# 2024 Site Management Plan

Defense Depot Memphis, Tennessee U.S. EPA I.D. Number TN4210020570

Revision 1 Final April 2024

**Subject:** 2024 Site Management Plan (Rev 0)

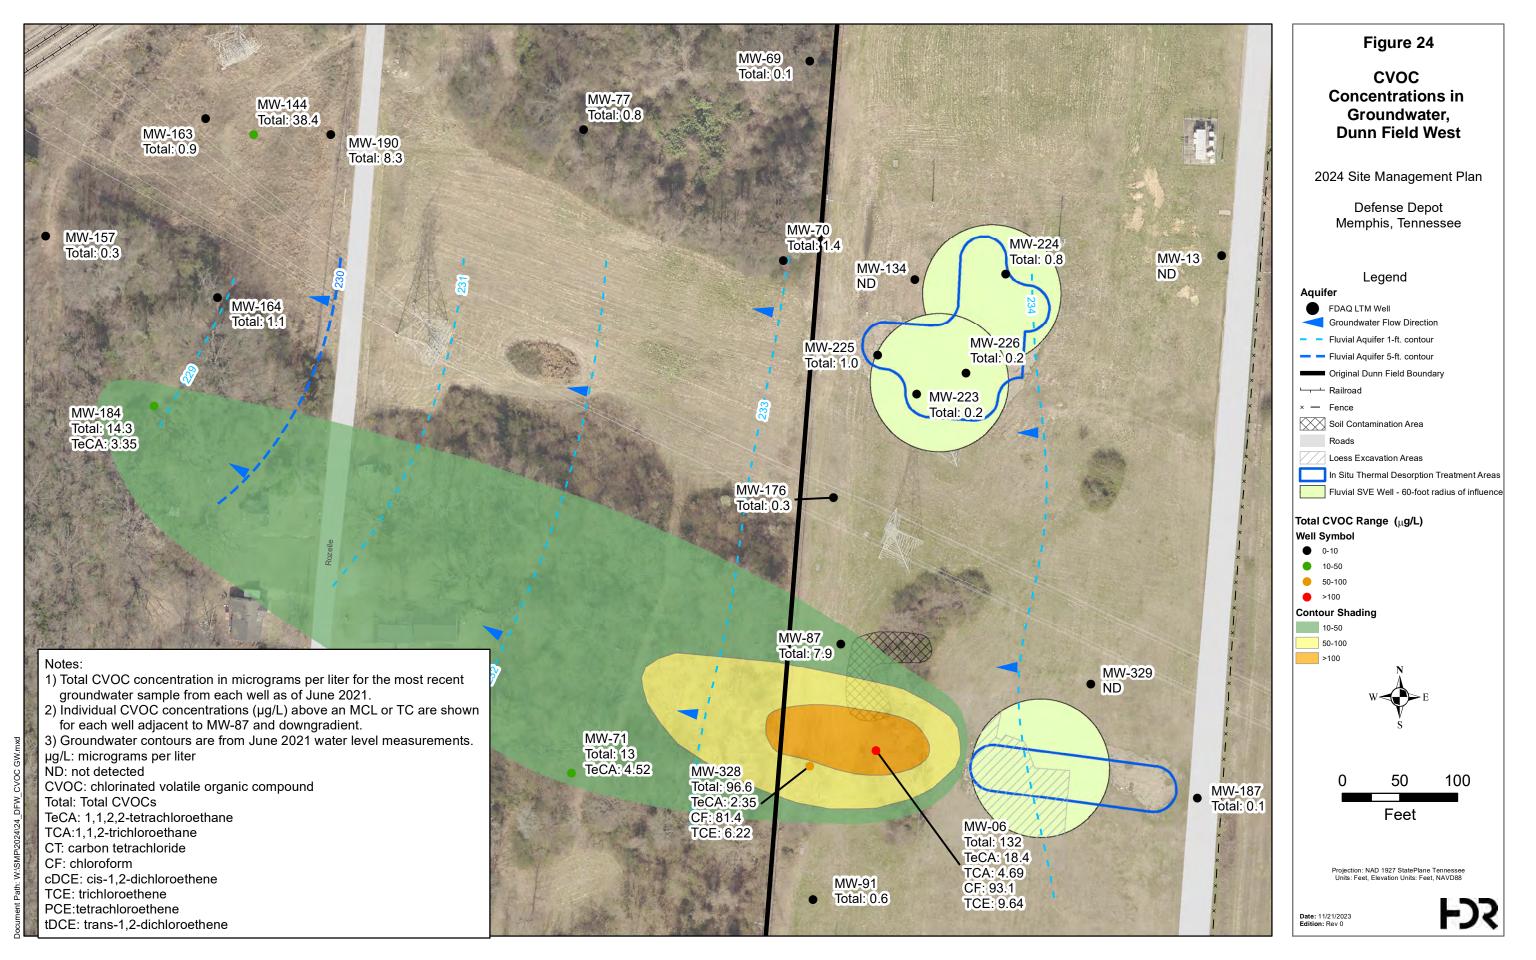
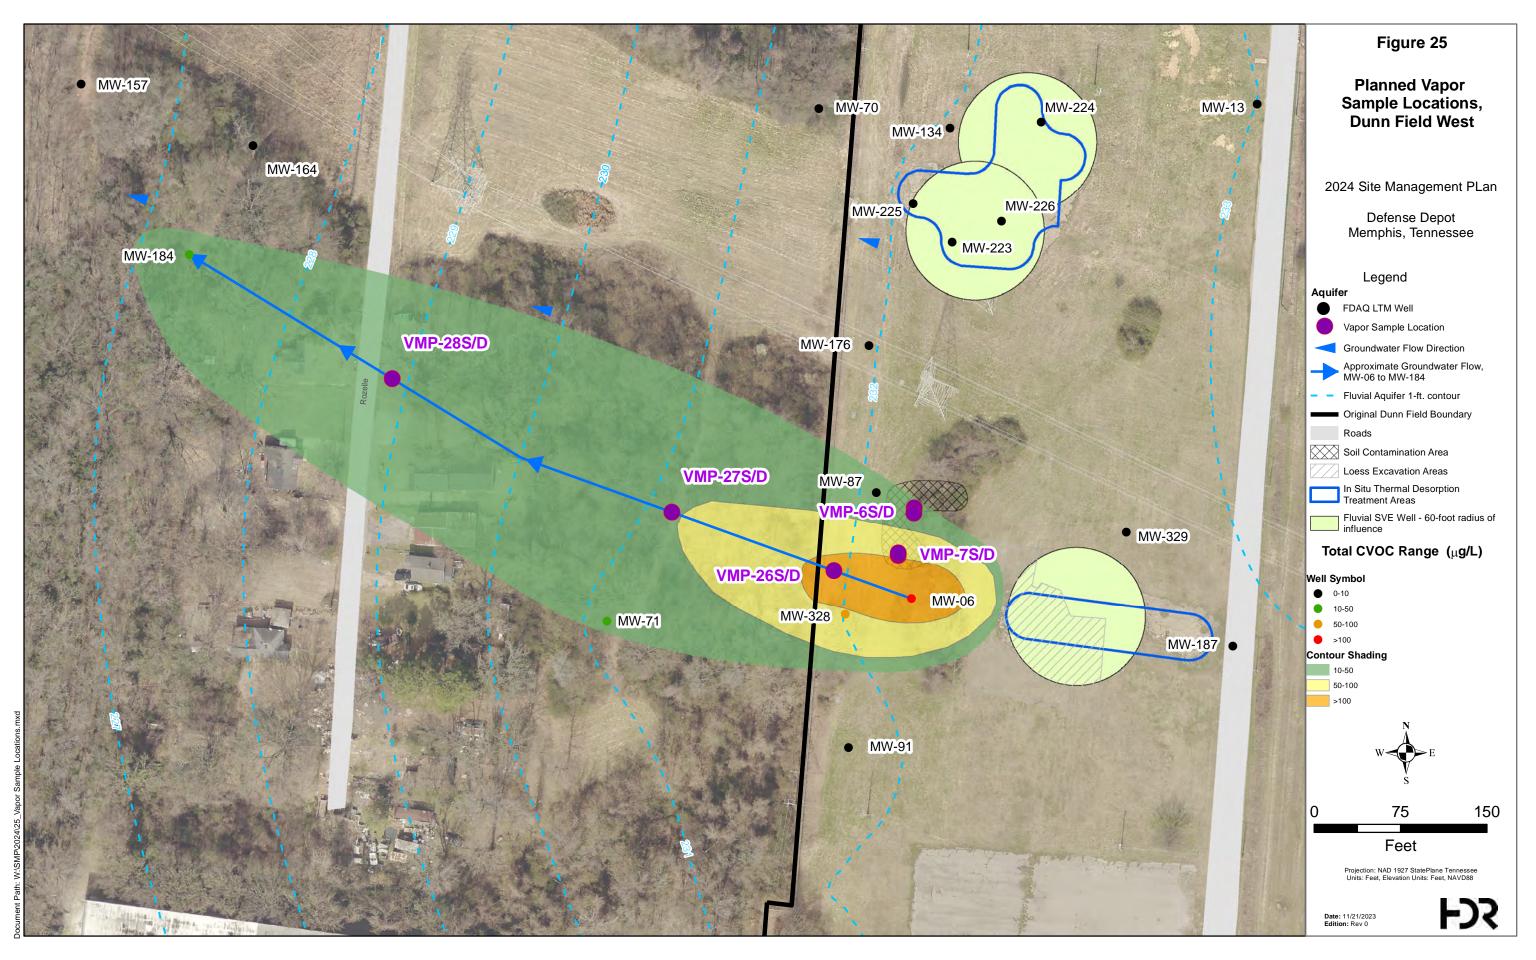
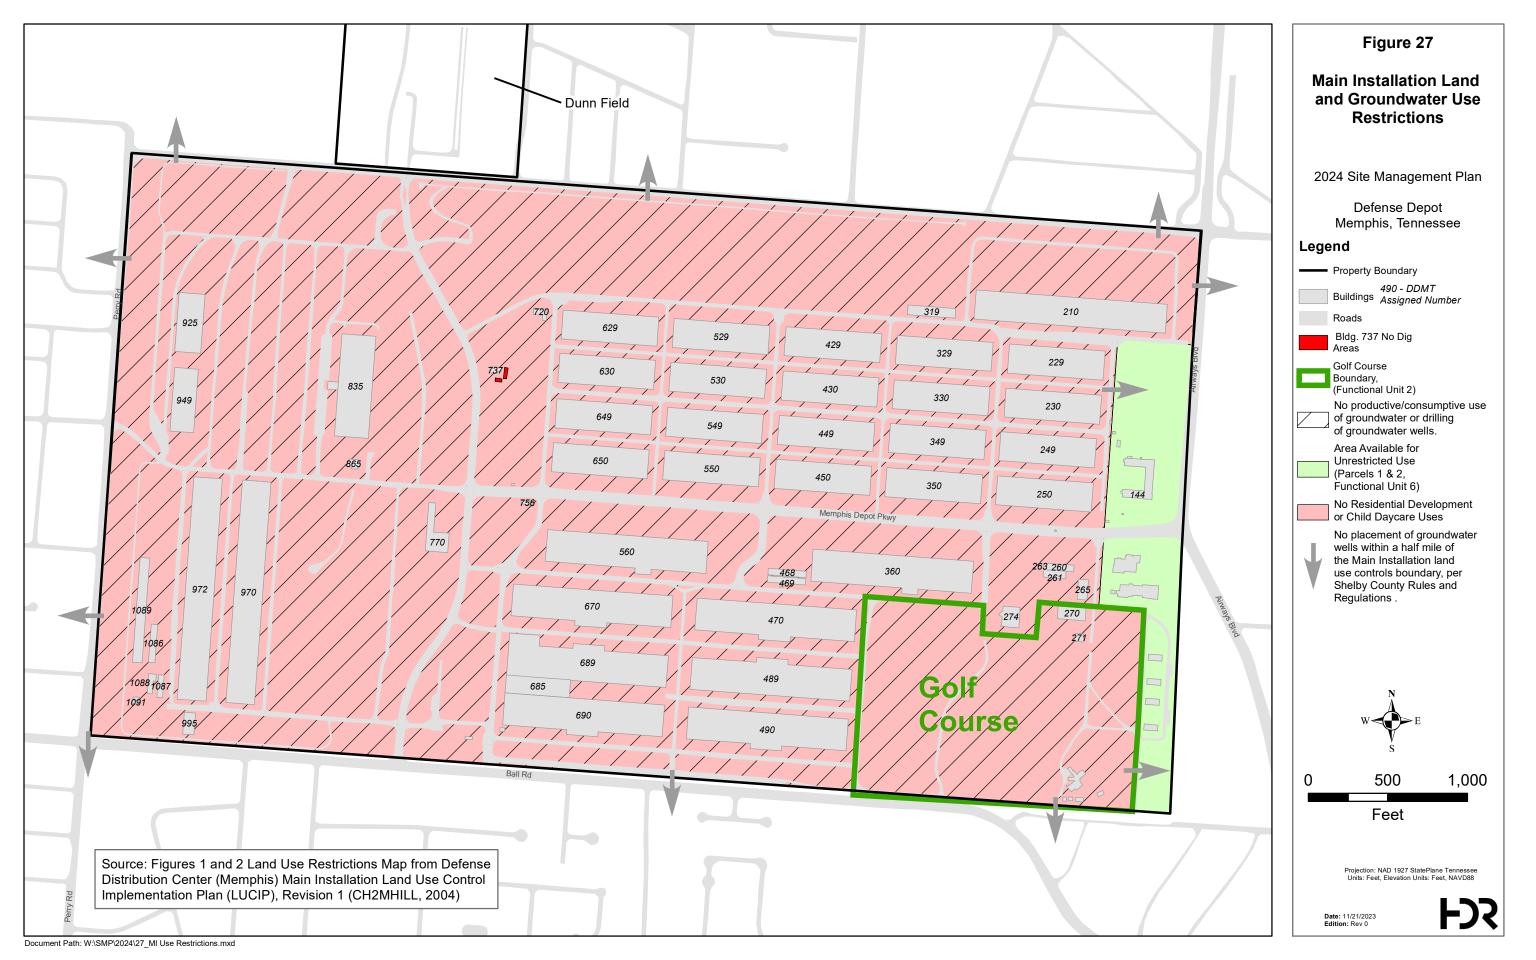
- 1. Section 3.1.5, Supplemental Remedial Investigation and Focused Feasibility Study, Page 3-5 and Figure 29, Master Schedule, PDF Page 103: It is unclear whether the Focused Feasibility Study (FFS) is on target with the Master Schedule. The Master Schedule indicates Revision 1 of the FFS will be completed by 12/20/2023; however, the text in Section 3.1.5 indicates resolution of the comments is ongoing. Please clarify whether the dates for the FFS in the Master Schedule are accurate and revise accordingly.

5. **Figure 29, Master Schedule, PDF Page 103 to 108:** The letters used under the "Status" column are not defined in the figure. For example, both "S" and "P" are used, but neither term is identified. Additionally, the Master Schedule does not clarify the current progress stage of each task. Please revise the Master Schedule to clarify the current progress stage of each task and define the designation letters used in the Status Column.
